To: Albemarle County Planning Commission
From: Mariah Gleason
Date: June 16, 2020
Item: **SUB202000021 Foothill Crossing Ph V - Modification Request** to waive the establishment of sidewalks on both sides of a public street as required under County Code §14-422.
Tax Map Parcel(s): 05600-00-00-057B3
Magisterial District: White Hall
School Districts: Western Albemarle H.S.; Henley M.S.; Crozet E.S.
Zoning District: R-6 Residential

**Regarding: SDP2020-013 – Foothill Crossing Phase V Final Site Plan
Request for an Exception to the sidewalk requirement**

ATTACHMENT B – STAFF ANALYSIS

Re: **Crozet Park Perimeter Trail Access**

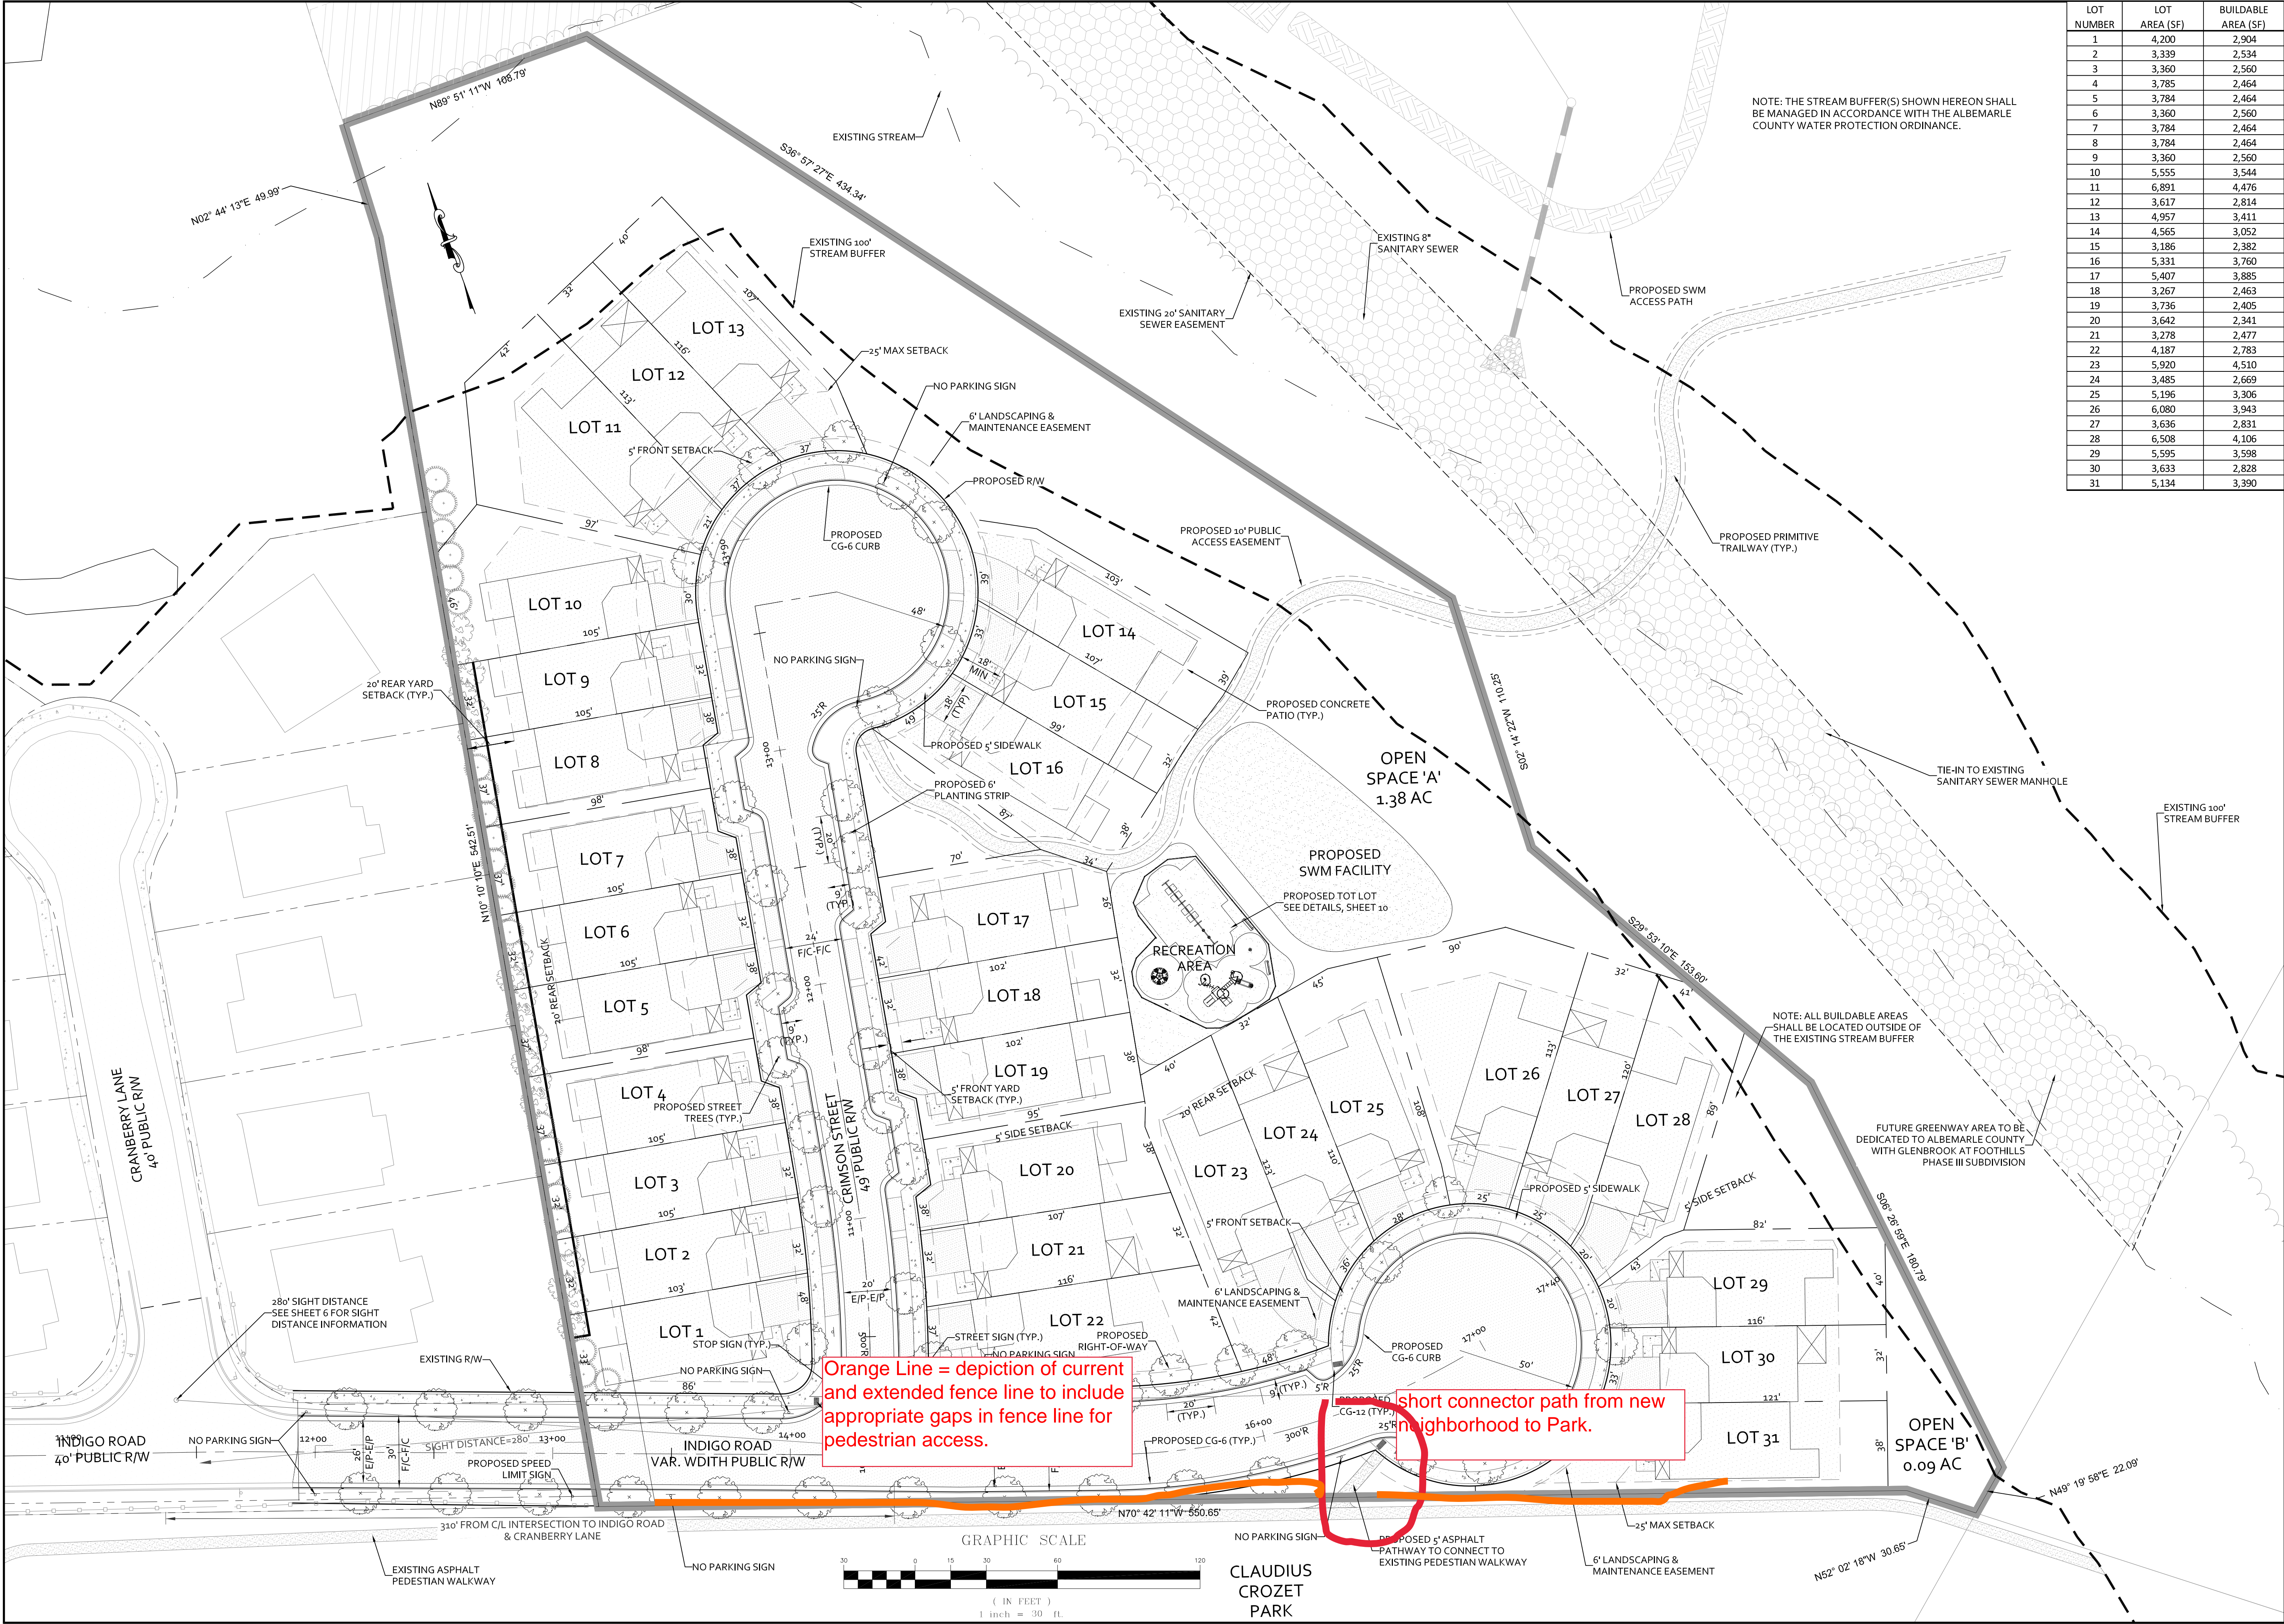
The Crozet Park Board of Directors approves the "Proposed 5' Asphalt Pathway To Connect To Existing Pedestrian Walkway" as shown on the attached Exhibit A. Stanley Martin Companies, LLC shall be wholly responsible for installing the proposed connection to the walkway.

Additionally, Stanley Martin Companies, LLC will extend the three-board fence along the shared boundary as shown in Exhibit A. This would take the existing fence line to the Park's NE boundary.

Orange Line = depiction of current and extended fence line to include appropriate gaps in fence line for pedestrian access.

Short connector path from new neighborhood to Park.

FOOTHILL CROSSING PHASE V - ROAD PLAN
SITE PLAN

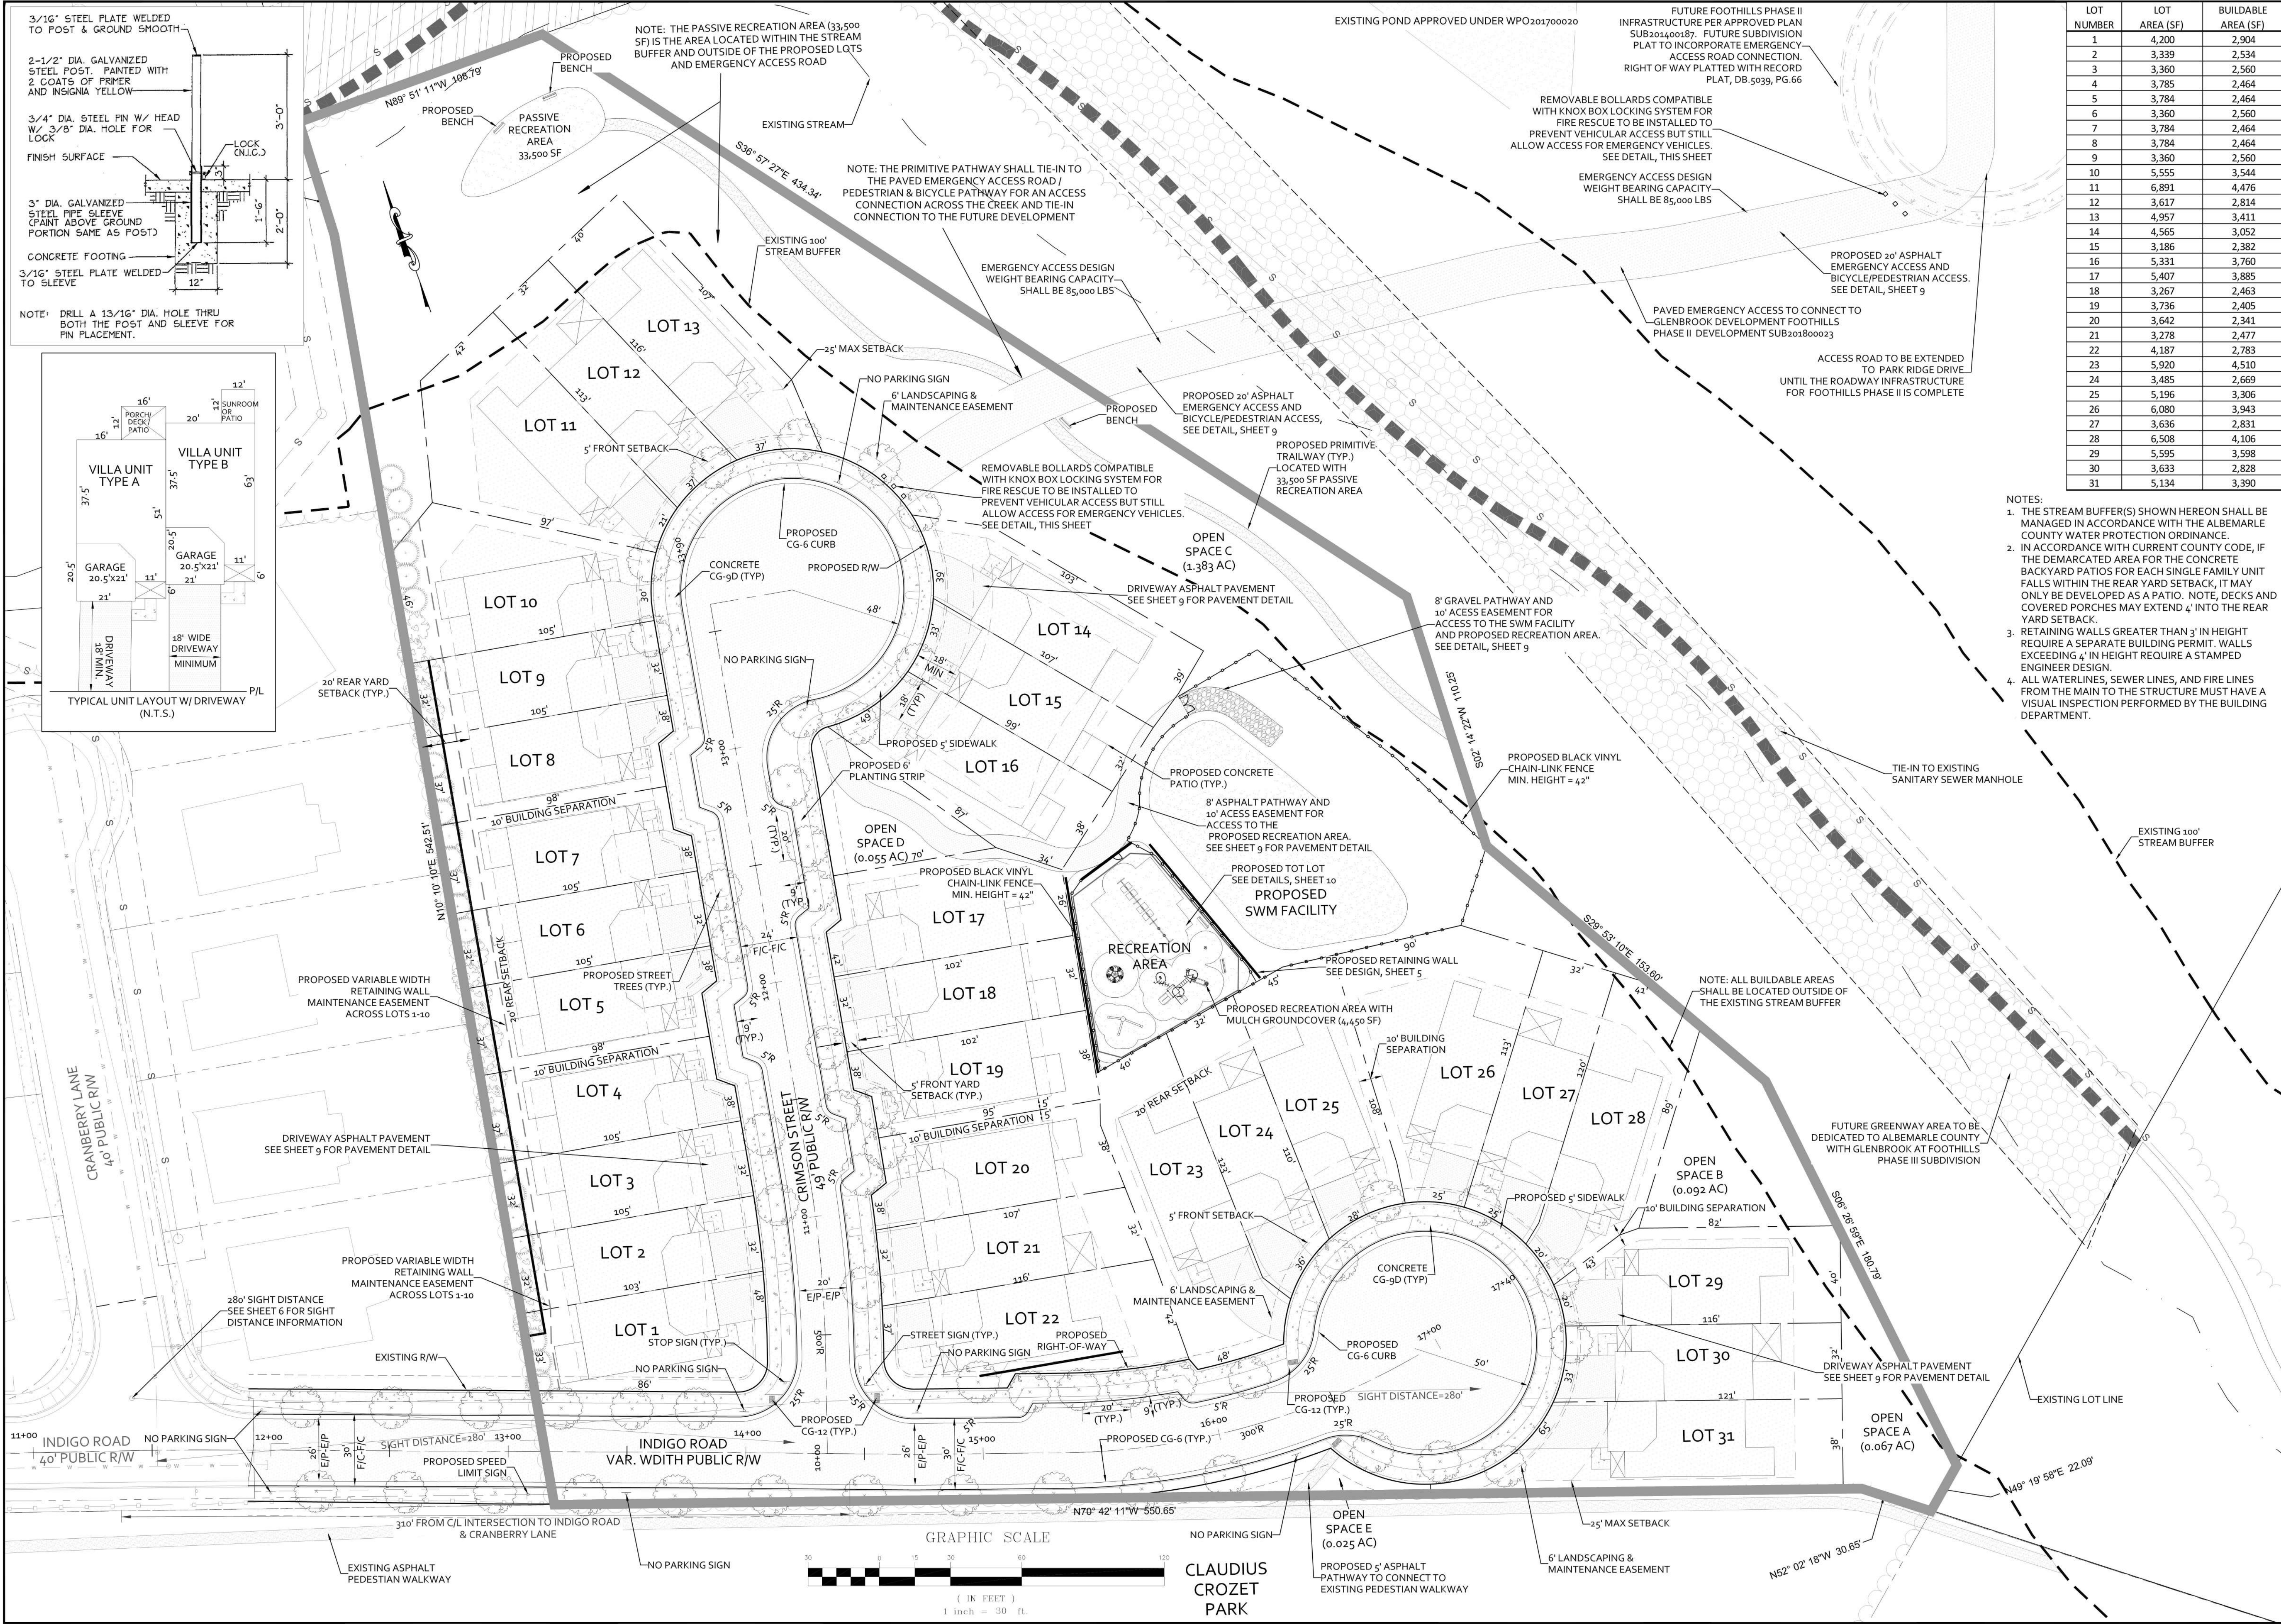
The applicant is requesting a modification of the requirement to provide sidewalk facilities on the south side of an extended portion of Indigo Road. This road will serve as the entrance to this development. In lieu of providing sidewalks on the south side of Indigo Road, where no residential lots are proposed, the applicant proposes a connection to existing pedestrian facilities in Claudius Crozet Park that run parallel and adjacent to locations where sidewalks would otherwise be required. A letter of approval from the President of the Crozet Park Board of Directors for the connection to the park's walkways is included in Attachment 1. It is worth noting that this is a private park and may not always remain a park in the future.

The existing Indigo Road, which serves as the entrance roadway into the development, currently has a sidewalk on the north side of the roadway, adjacent to the development lots. The existing roadway does not have a sidewalk on the southern portion of the roadway, adjacent to the Crozet Park. However, there is an existing 5' to 6' asphalt pathway running parallel to the existing roadway within the Park. This existing asphalt pathway continues along the entire portion of the existing Indigo roadway and continues along proposed portion of the roadway extension of Indigo Road within the limits of this development. Because there is an existing asphalt pathway along the southern portion of the Indigo Road right of way and because there are no proposed development lots along the southern portion of Indigo Road, we are requesting an exception for the requirement of a sidewalk on this portion of the roadway. A planting strip will still be provided along this portion of the roadway, and a sidewalk and planting strip will be provided on the northern portion of Indigo Road. However, since there is an existing asphalt pathway parallel to this roadway within five feet to ten feet of the right of way, adding a sidewalk on the southern side of the roadway parallel to the existing pathway is redundant and not necessary.

As shown in the development plans, the other roadway within the development will have sidewalks and planting strips on both sides of the roadway, as required by the County Ordinance. All portions of the proposed roadway adjacent to the development lots will have the required 6' planting strip and 5' concrete sidewalk. The only portion of the proposed roadway where an exception is being requested is adjacent to the existing Crozet Park. In addition, attached is a letter from the Crozet Park board allowing an asphalt pathway connection from the proposed sidewalks within this development to the existing asphalt pathway within the Crozet Park. This connection is a benefit to the community, allowing access to the park from this proposed development and the adjacent neighborhoods.

With regards to the findings contained in the Staff Analysis (Attachment 2), inclusive of the criteria to be considered pursuant to Albemarle County Code §14-422(E)(2), **staff recommends approval** of this modification request with the following condition:

1. The locations of sidewalks for the Foothill Crossing Phase V development must be in general accord with the sidewalk locations as shown on the plans entitled "Foothill Crossing Phase V - Road Plans, SUB2020-00021," which were prepared by Collins Engineering and are last dated March 30, 2020.
